**ADDENDUM NO. 2**

**RE: Item #3, March 4, 2026 Letting - NH 0037(166)73, CR 0907(91)330, PCN 06WT, 09HU,  
Davison County - Curb Ramps, Sidewalk, Signal & Lighting**

# CONDUIT LAYOUT EXIT 330, RAMP D & C

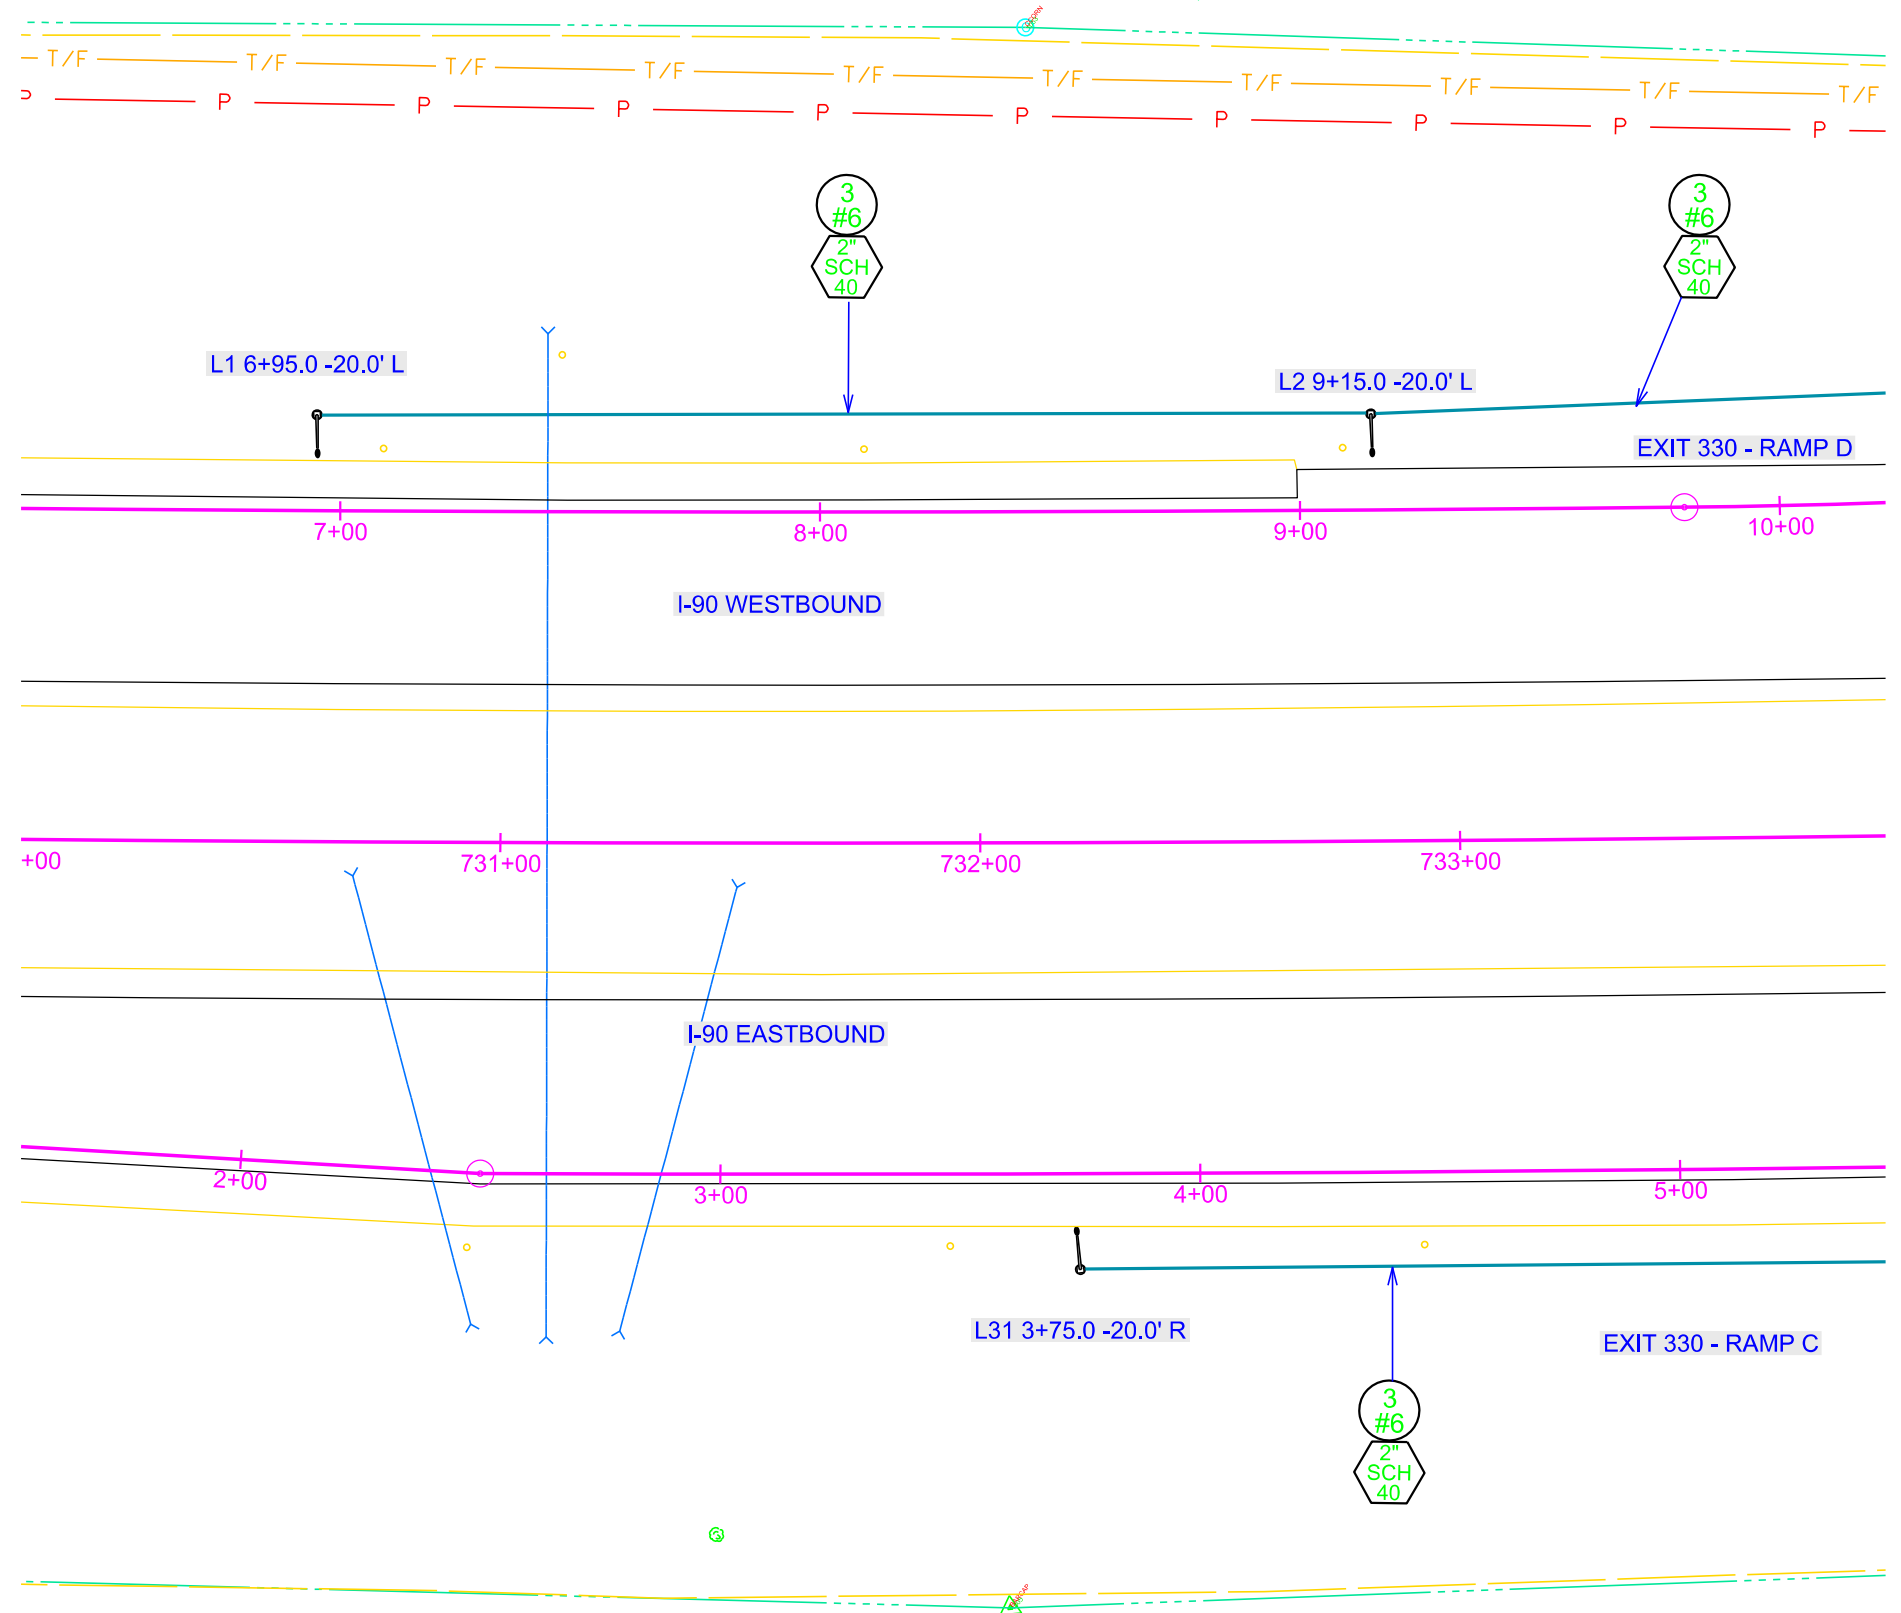
**Sheet L18:** ESTIMATE OF QUANTITIES table was revised.

# CONDUIT LAYOUT EXIT 332, RAMP D & C

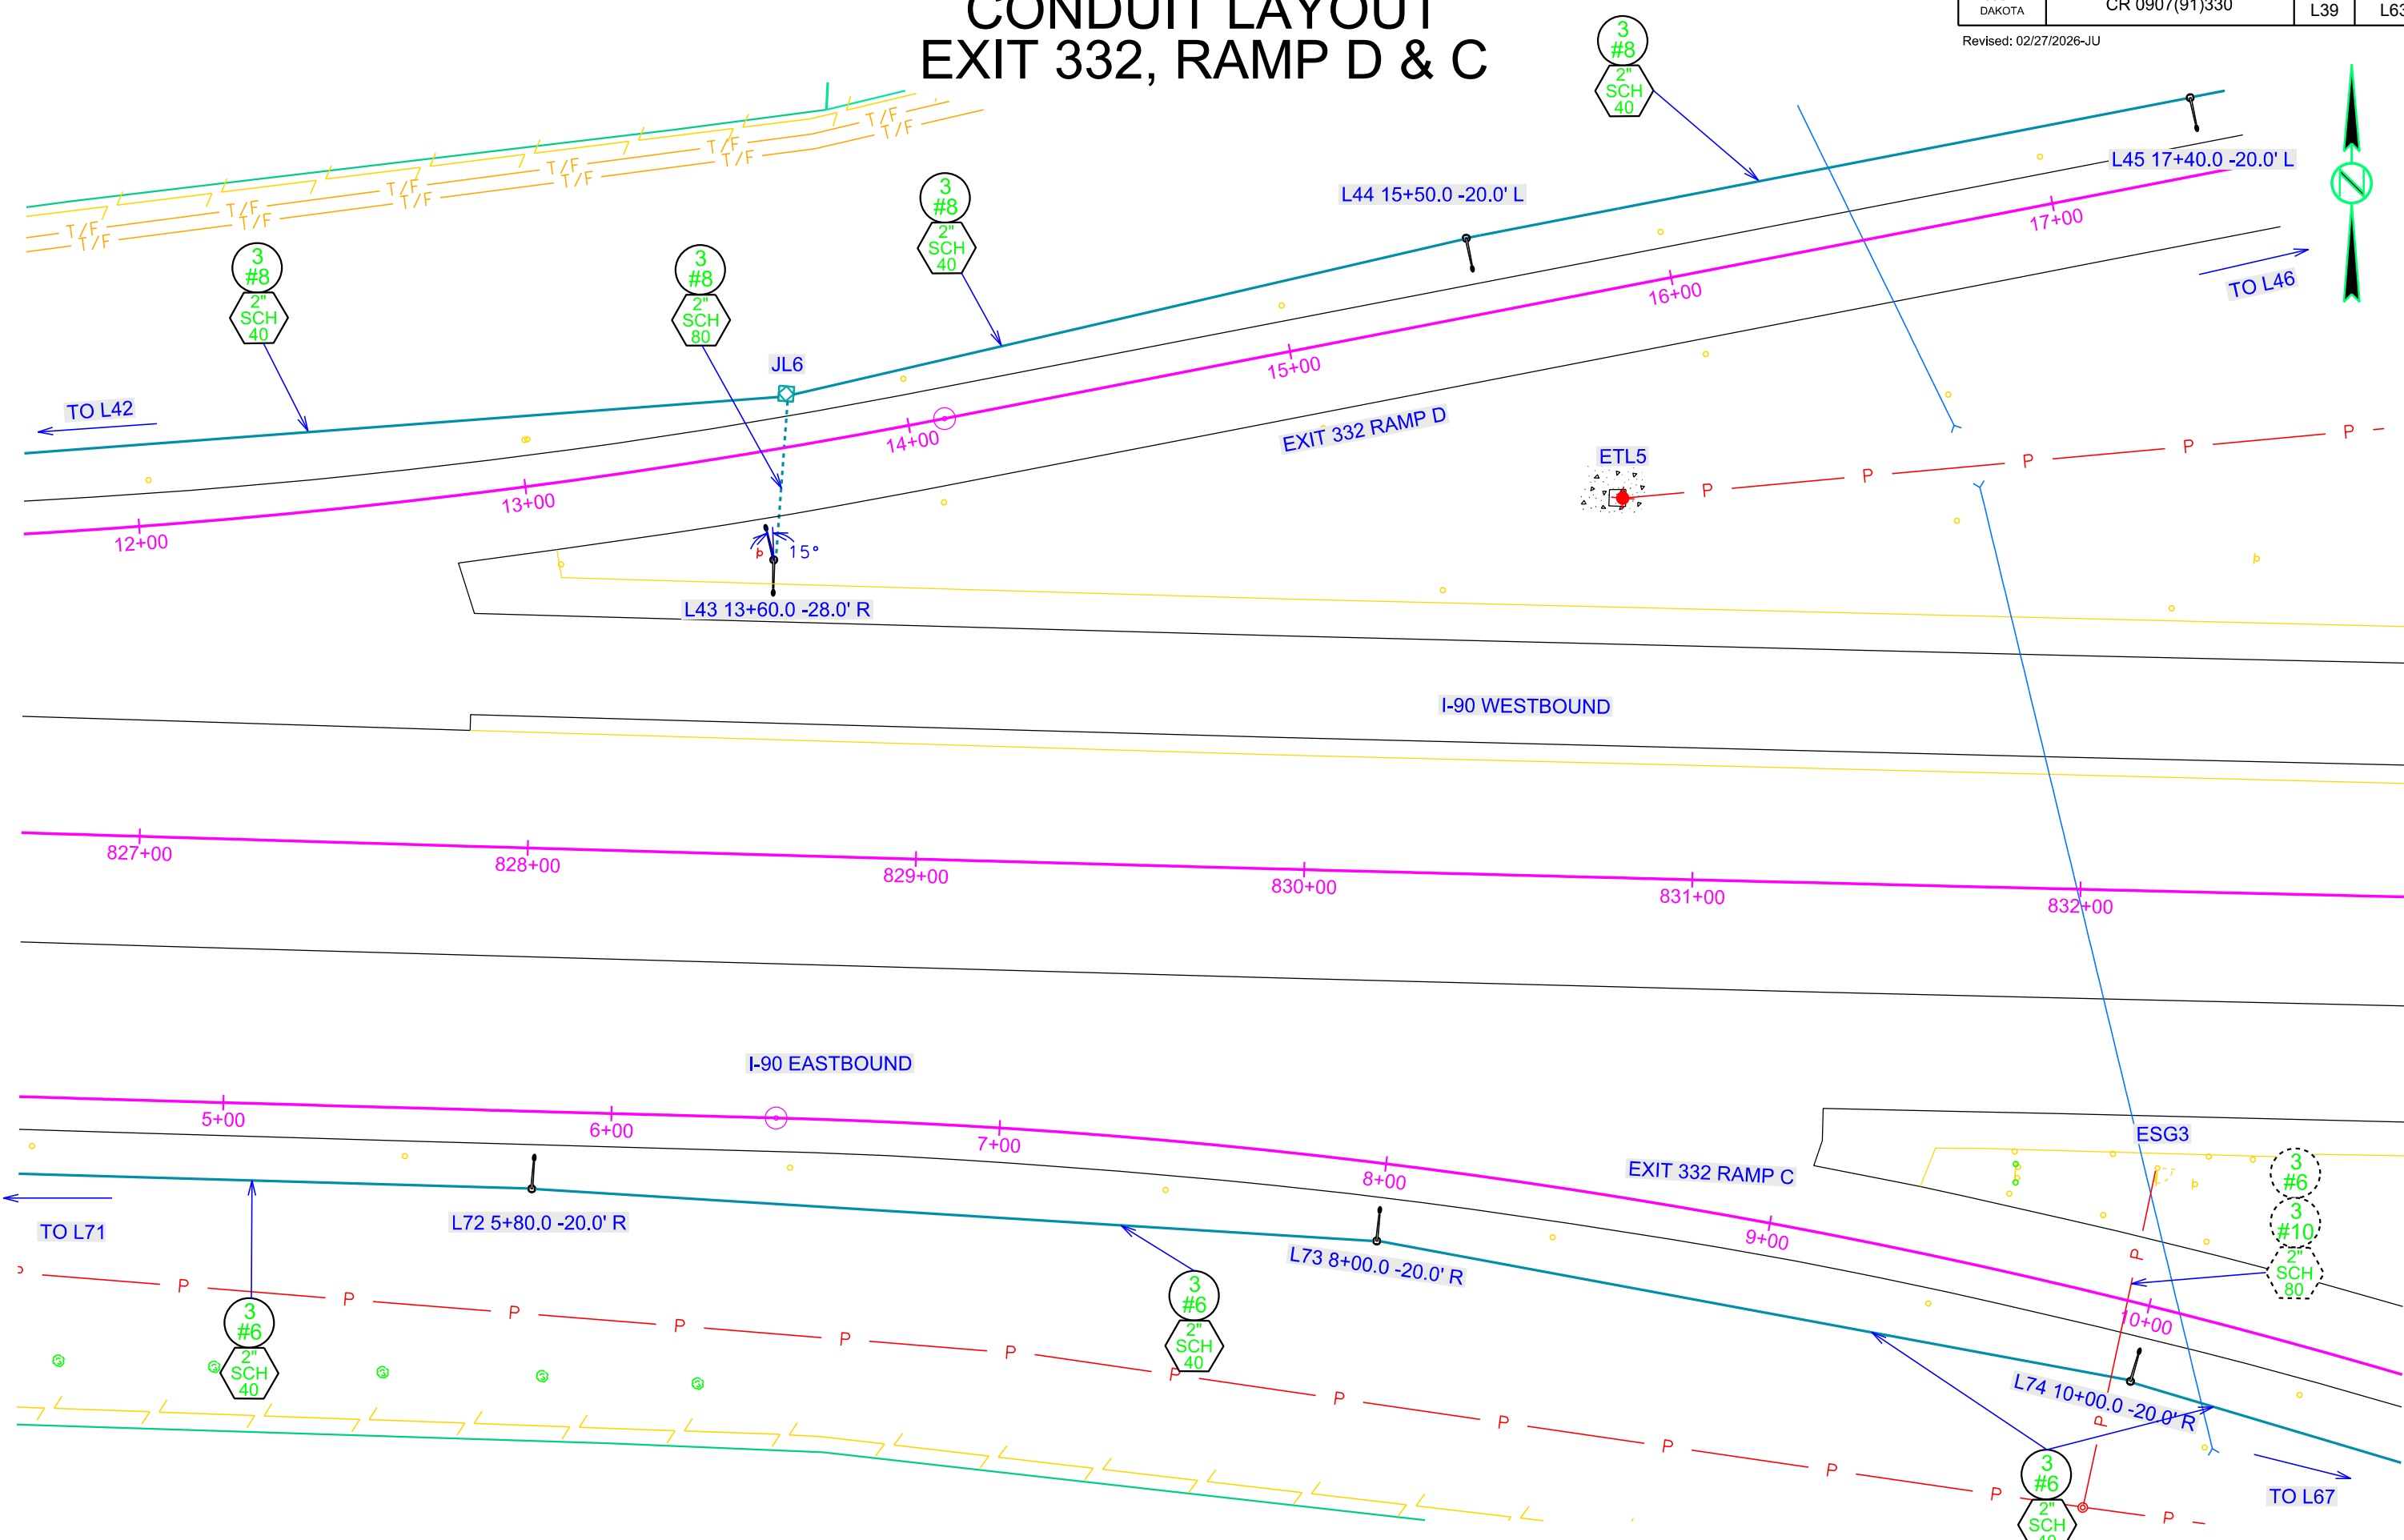
**Sheet L39:** CONDUIT LAYOUT was revised to show L45.
